2014 PUBLIC COMMENT AGENDA FOR THE PROPOSED CHANGES TO THE 2012 IgCC

October 1 — 4, 2014

First Printing

Figure 1- impact of encroachments into riverine flood hazard areas

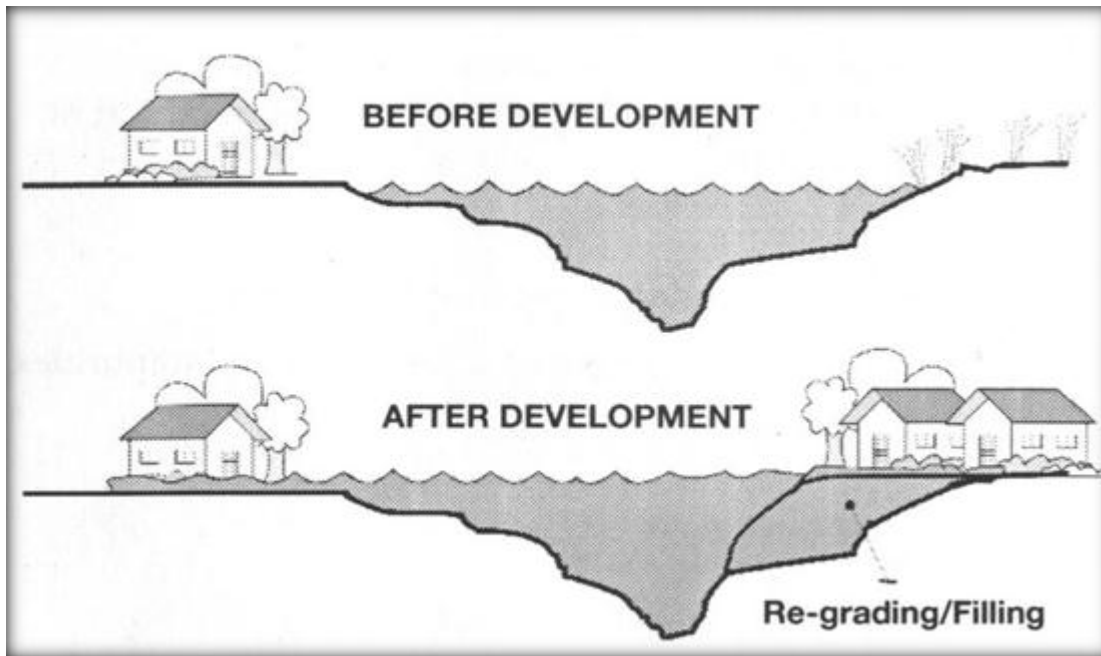
Reason: The costs of recovering from floods are the highest of all natural disasters and even with substantial federal, state and local government risk management efforts damage costs are on a steady upward trend. One of the reasons that the costs associated with flood recovery are increasing is encroachments into the floodplain (Galloway, 2013). Current minimum standards of the National Flood Insurance Program and the International Code Series -- and the current *International green Construction Code* -- allow encroachments into riverine floodplains that can cause up to a foot of increased flooding (see figure 1 below). These encroachments on-average pinch in conveyance areas to half their normal width, increase flood velocities by one-third and cause the extent of the flood hazard area to increase by 10 percent (Luloff, 2013).

It is important to note that this section, as written, only applies in riverine flood hazard areas, not in areas subject to coastal flooding where encroachments such as fill do not affect the base flood elevation in the same way they affect riverine floodplains.

FIGURE 505.3.1
HAIL EXPOSURE MAP

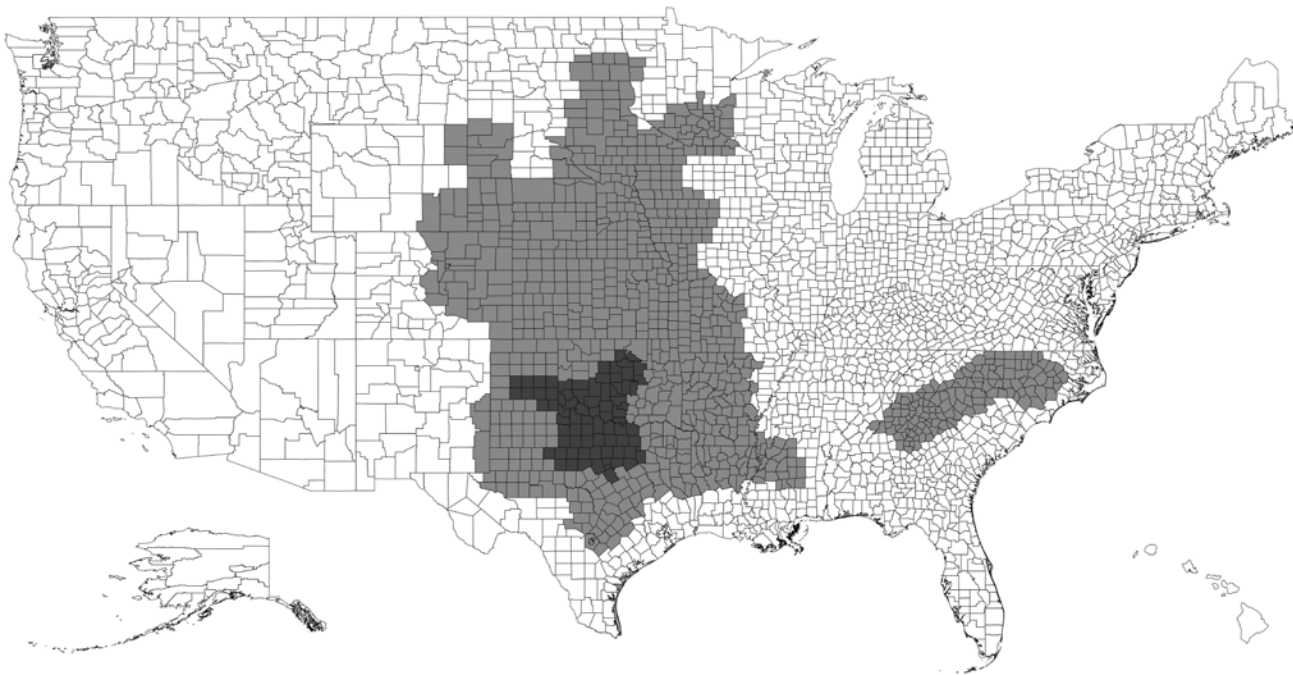
505.3 Roof coverings subject to hail exposure. Where indicated by Table 302.1, roof coverings used in regions where hail exposure is moderate or severe, as determined in accordance with Section 505.3.1 and Figure 505.3 shall be tested, listed, and labeled as Class 3 or Class 4 respectively in accordance with UL2218.

505.3.1 Hail exposure regions. Hail Exposure regions in Figure 505.3.1 shall be as follows:

1. Clarifies that UL 2218 is only applicable to steep slope roofs, a limitation in the scope of the standard.
2. Removes the Figure 505.3.1 hail exposure region map, which is not needed, because the jurisdiction will determine if they have moderate or severe hail exposure, and if they need to require roof covering that has been evaluated for such conditions in accordance with Table 302.1.
3. Retains a description of moderate and severe hail exposures as a convenience to the user, using criteria that was developed by IBHS Research based on field data obtained from the National Climate Data Center.

505.3 Roof coverings subject to hail exposure. Where indicated by Table 302.1, roof coverings on a slope greater than 2:12 used in regions where hail exposure is moderate or severe, as determined in accordance with Section 505.3.1 and Figure 505.3 shall be tested, listed, and labeled as Class 3 or Class 4 respectively in accordance with UL 2218. Hail exposure regions shall be as follows:

FIGURE 804.3

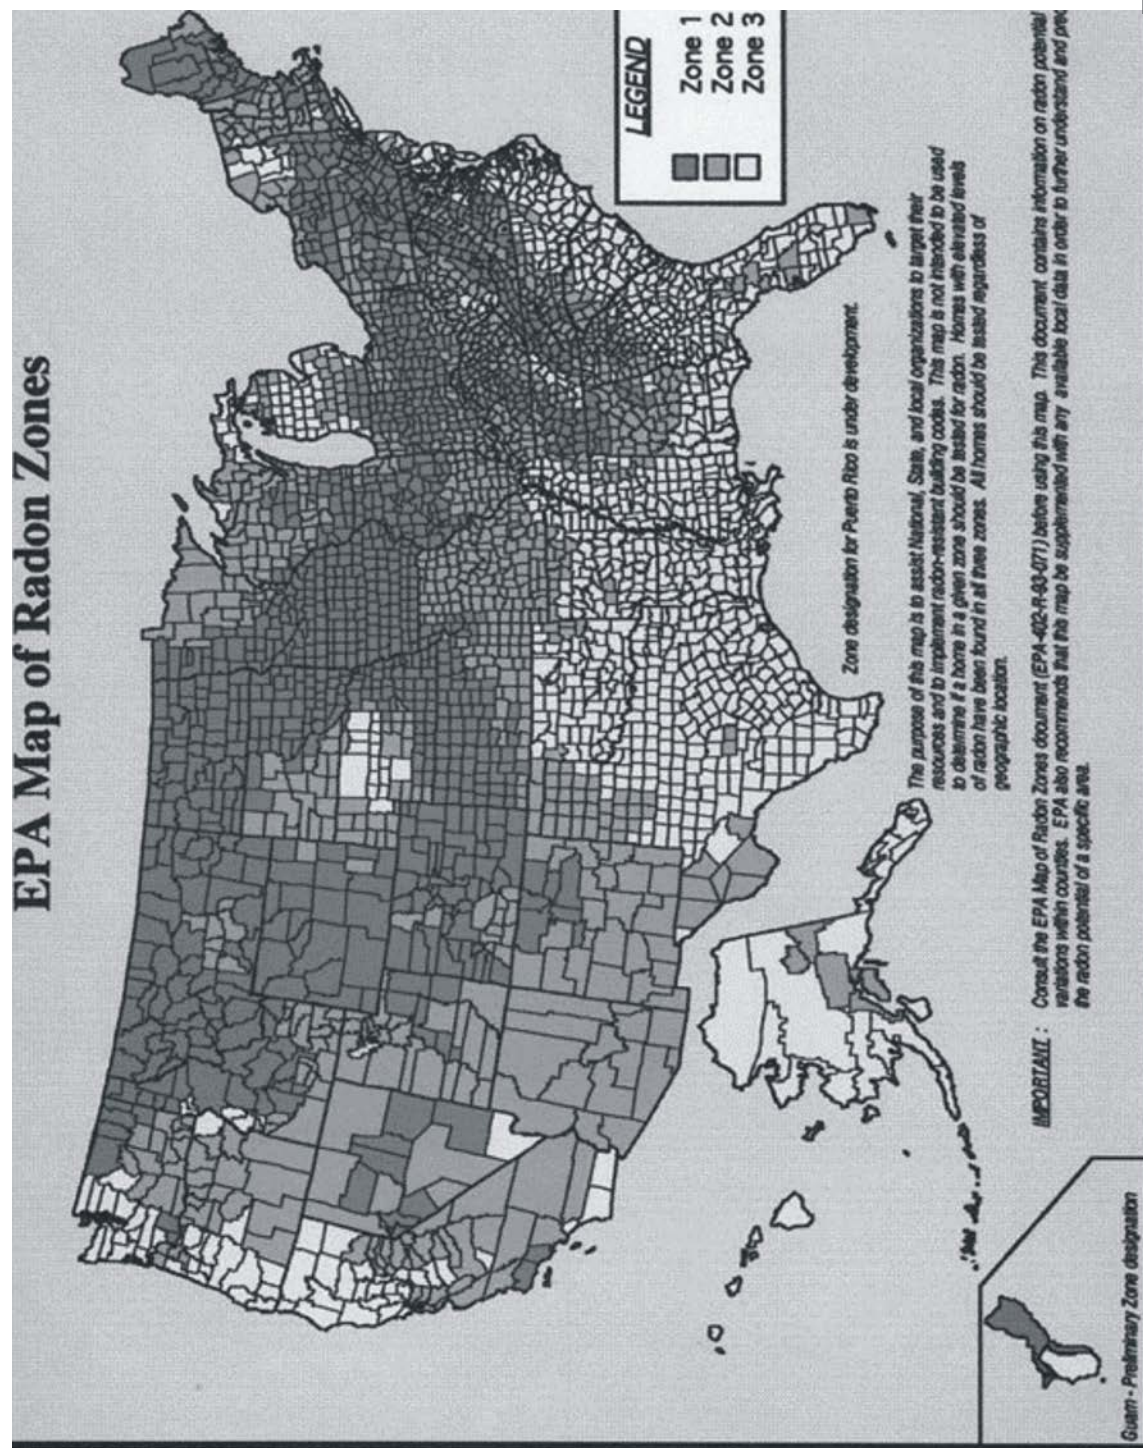
804.3 Radon Testing Where a building site indicates a potential for elevated indoor radon concentrations, as shown by the United States Environmental Protection Agency zones 1 and 2 in Figure 804.3 or from the United States Environmental Protection Agency radon potential by county listing in Table 804.3, radon testing shall be performed prior to occupancy of the building. Such testing shall be performed by a qualified radon measurement professional. Where state or local jurisdictions have published radon potential data, such data shall supersede the information in Figure 804.3 and Table 804.3. Indoor radon levels shall not exceed the United States Environmental Protection Agency Radon Action Level of 4 pCi/L.

FIGURE B101.1 FIGURE 809.1
EPA MAP OF RADON ZONES

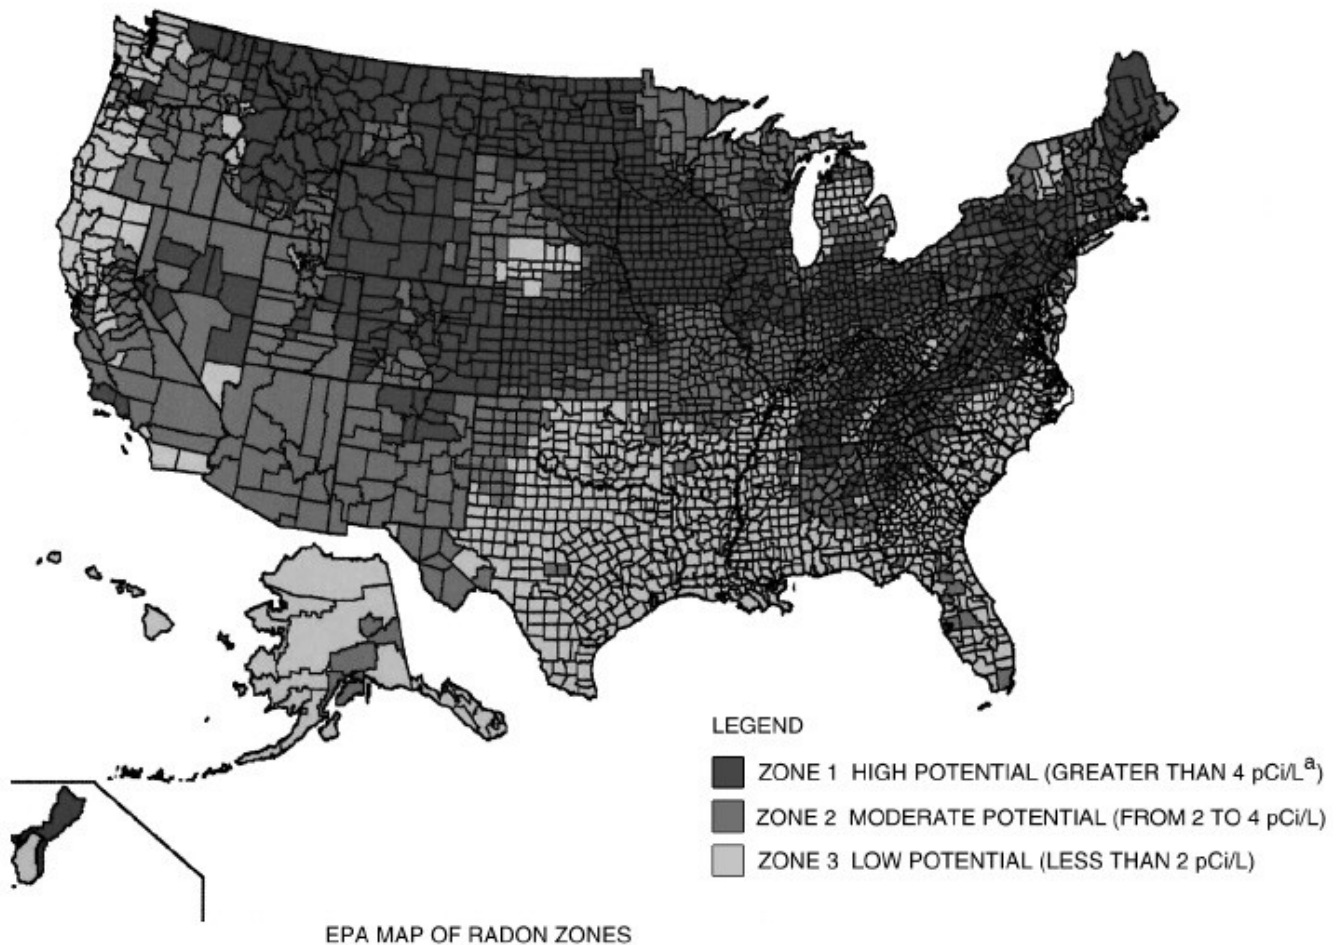
B101-809.1 Radon mitigation. Buildings in areas of High and Moderate Radon Potential (Zone 1 and 2), as determined by Figure 809.1 B101.4 and Table 809.1 B101.4 shall comply with Sections 809.2.1 B201.1 through 809.2.12 B201.10.

Figure 1 Increase in Property Losses Due to Natural Disasters, excluding Flood¹

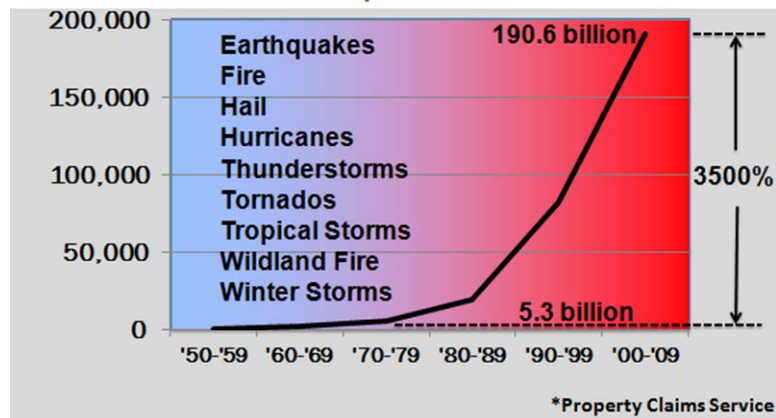
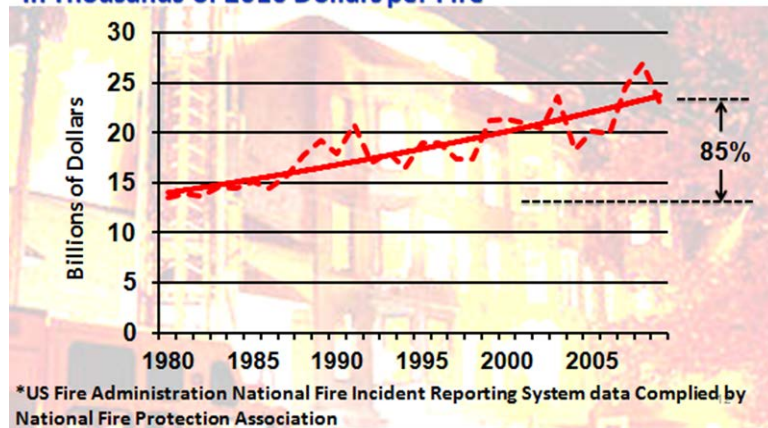
has 10% per decade or 40% over the same time period) property losses due to natural disasters, adjusted to 2010 dollars, have increased by over a staggering 3500%, see Figure 1. Losses from fire, adjusted to 2010 dollars, have increased by 85% per fire, see Figure 2.
